RE: Nuestros Valores Charter High School

Grading Plan

RE: Nuestros Valores Charter High School (Hydrology File L10/D007)
Grading Plan Resubmittal, Revised 5/25/2017

We are in receipt of your comments dated May 12, 2017 regarding the subject project. The revised plans are included with this resubmittal. Below are responses to the comments.

C101

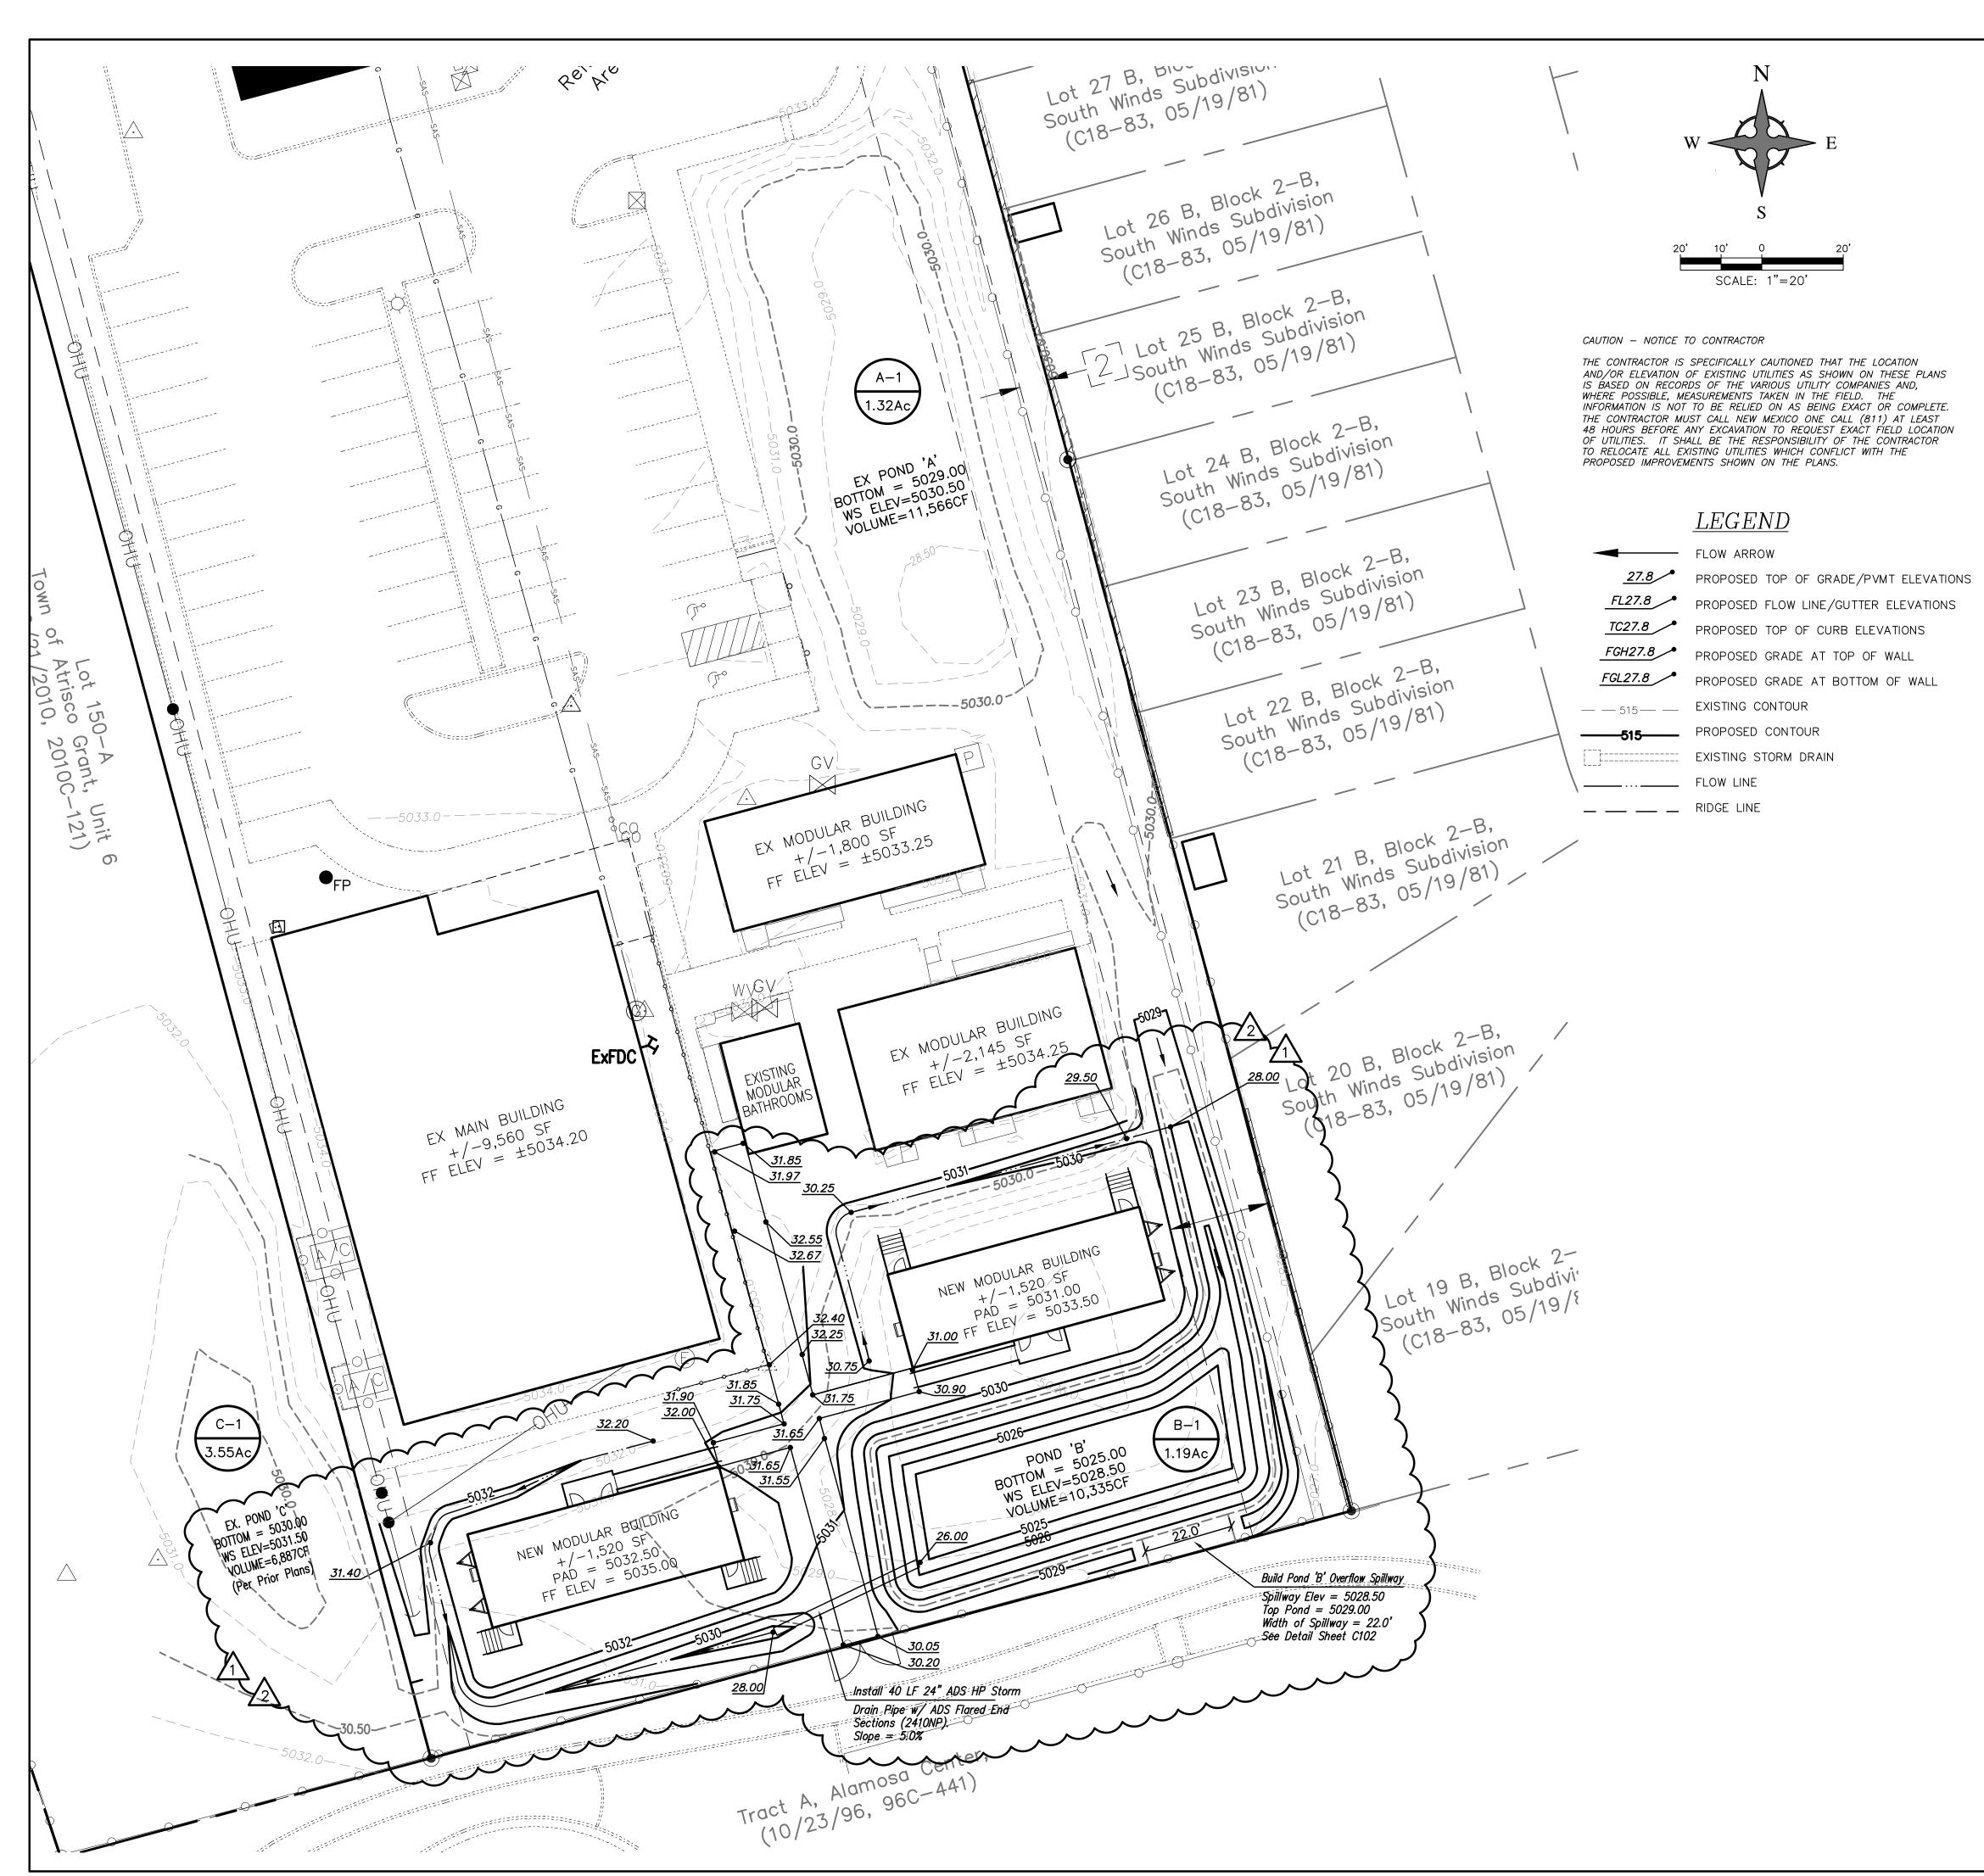
- 1. The benchmark information has been added under the Zone Atlas Page.
- 2. Per our prior email correspondence, Pond 'B' has been revised to capture the 100-Yr, 10-day storm.
- 3. AHYMO routing is not typically required for retention ponds. The calculation of the 100-Yr, 10-day storm is a direct calculation per the DPM and is reflected on the Drainage Calculations table on Sheet C102.
- 4. Per our prior email correspondence, Pond 'A' is to remain as existing per the prior design by Applied Engineering and Surveying, Inc. Pond 'B' has been revised to capture the 100-Yr, 10-day storm.
- 5. Per our prior email correspondence, Pond 'A' is to remain as existing per the prior design by Applied Engineering and Surveying, Inc. Pond 'B' has been revised to capture the 100-Yr, 10-day storm.
- 6. The Basin Map has been added per your request.
